Re: In the Matter of Avista Natural Gas
Integrated Resource Plan
OPUC Docket No. LC 81

Docket No. LC 81

Staff Final Comments

Figure 1: Comparison of Green Hydrogen Cost Trajectories

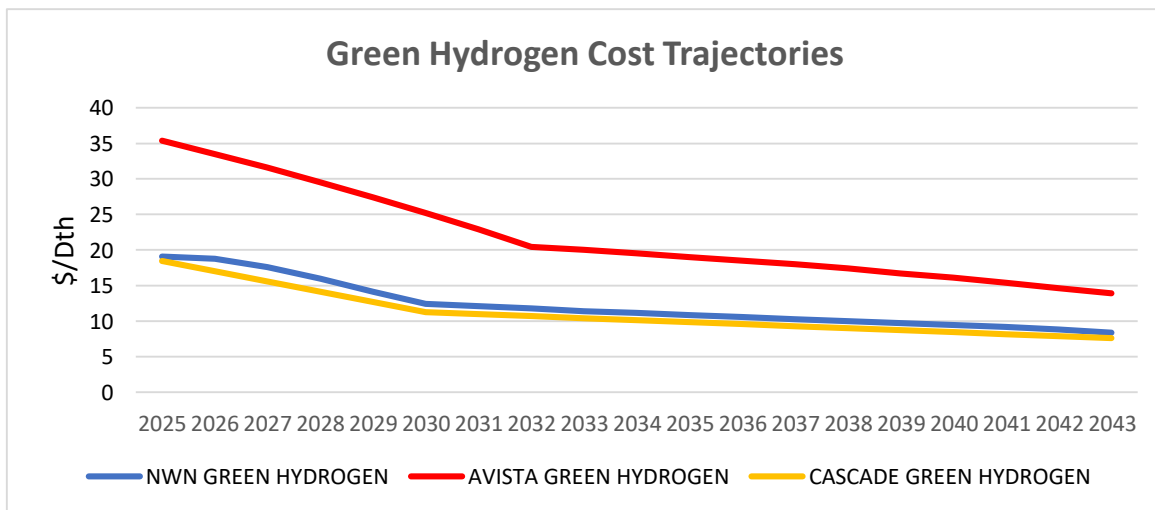
Staff agrees with CUB’s assessment of the risks associated with synthetic methane, however, differs slightly regarding CUB’s assertion that Avista needs to rely on an “established method.” Staff supports Avista’s efforts to project new supply side resource costs and availability and encourages Avista to explore and critique objective third-party sources that could be used to project costs and availability as part of the TAC process for developing future IRPs. While Avista’s estimates for green hydrogen costs as a feedstock to synthetic methane are conservative when compared against NW Natural and Cascade, as shown in Figure 1,⁷ Staff remains concerned about the Company’s ability to produce or procure the green hydrogen required to produce synthetic methane at the scale projected by Avista in its IRP.

*Figure 2:
Comparison of
Dairy RNG IRP
Estimate and RFP
Bids*

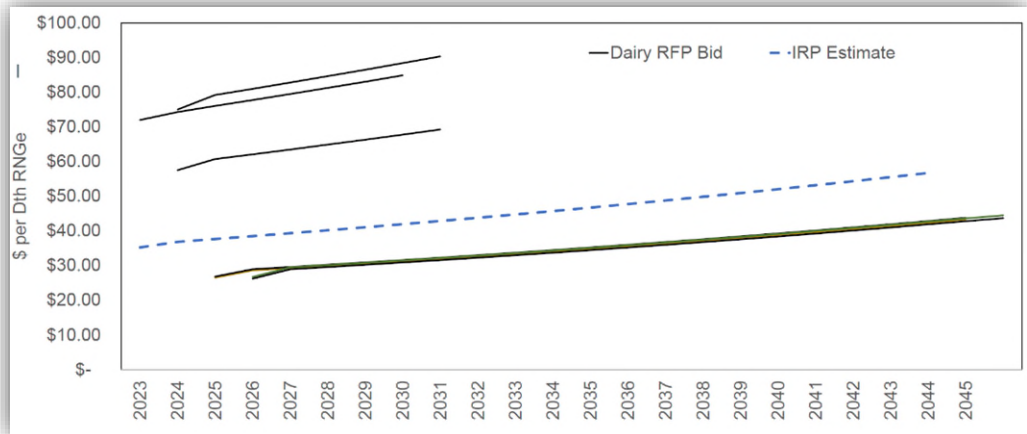
Avista addresses Staff’s request regarding how cost assumptions have changed since the 2018 Black & Veatch report by providing four charts comparing RNG pricing of the “IRP Estimate” derived from the report versus RFP bids Avista received.²² Of the four charts, only Avista’s solid waste IRP estimate is perceivably higher than then RFP bids. Avista’s IRP estimate for landfill and wastewater RNG is much lower than at least a majority, if not all the RFP bids. Dairy is likely closer to the middle of pricing based on the RFP bids, but without detailed workpapers, also appears perceivably lower than average. Avista states that the RFP prices consider market factors including Low Carbon Fuel Standard (LCFS) and Renewable Identification Number (RIN) program in the bid price.

Staff agrees with CUB that the RNG pricing is unreasonably low and that this undermines the Oregon PRS and IRP long-term plan generally.²³ While RNG is not the Company’s primary CPP compliance resource, it remains a consistently large resource in the PRS, starting in the near-term and maintaining importance throughout. If the resource is being underpriced, this could have negative impacts particularly on utilization of CCI and DSM programs, each of which represent smaller portions of the resource mix. The RNG cost comparison charts provided by Avista reinforces this concern. IRP RNG pricing that does not include important market factors, including LCFS and RIN program pricing, are unreasonably low and do not accurately represent the cost of RNG, therefore, lead to RNG to potentially overcrowding the Company’s Oregon PRS

Figure 6: NW Natural meter counts showing the return of a 2011-2015 trend of where meters decline in Q2-Q3 before rebounding in Q4 and Q1. The trailing 12-month growth rate is also at an all-time low since 2012.

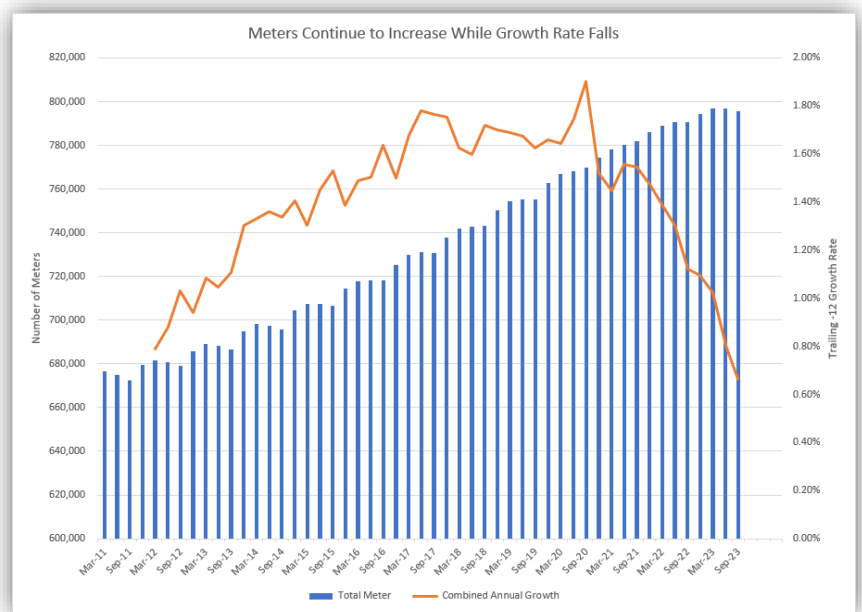
To start to understand baseline electrification occurring naturally, Staff recommends Avista use advanced metering infrastructure data and Form 10Q data to capture customer behavior. By the next IRP, Avista should present that information in the worksheet template included as Attachment B. An example of captured customer behavior from NW Natural’s Form 10Q is shown in Figure 6. This graph shows that even as meters increase, growth rate falls, suggesting increased energy efficiency measures and the natural electrification of end-

Figure 7: Forecast Space Heat Costs

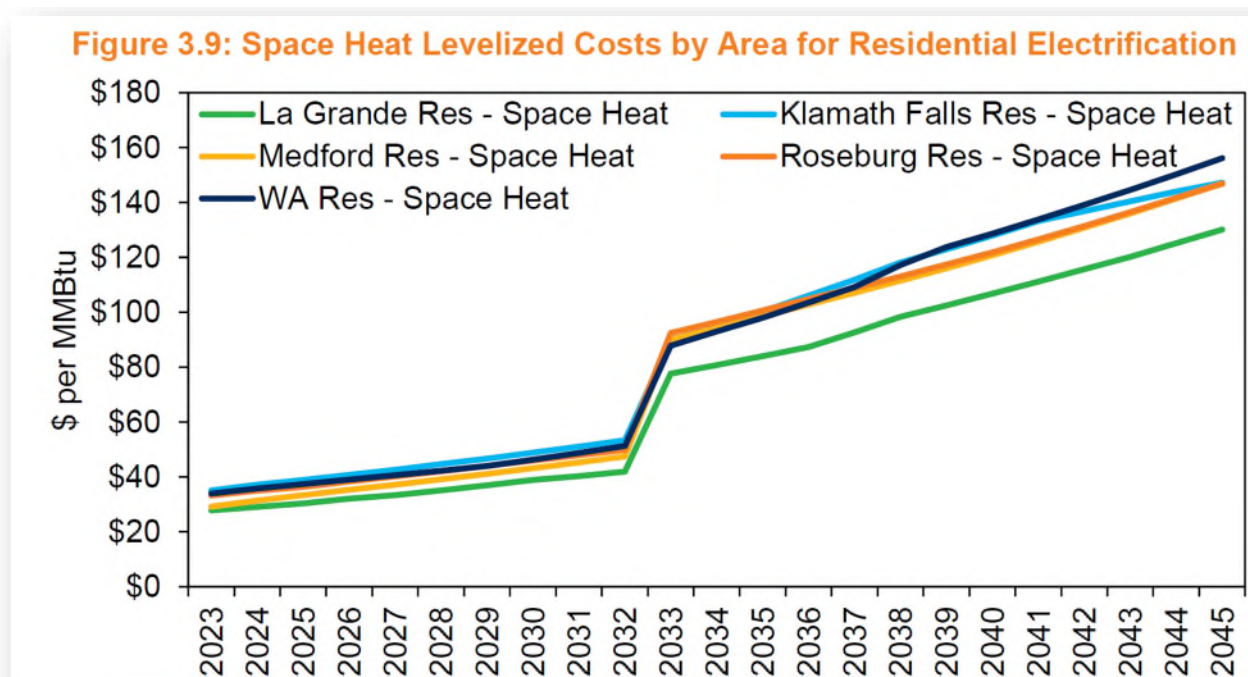
Figure 7 below shows Avista’s forecasted cost for electric space heat inclusive of a 50 percent reduction in conversion costs for IRA incentives and increasing electric rates.¹⁴³
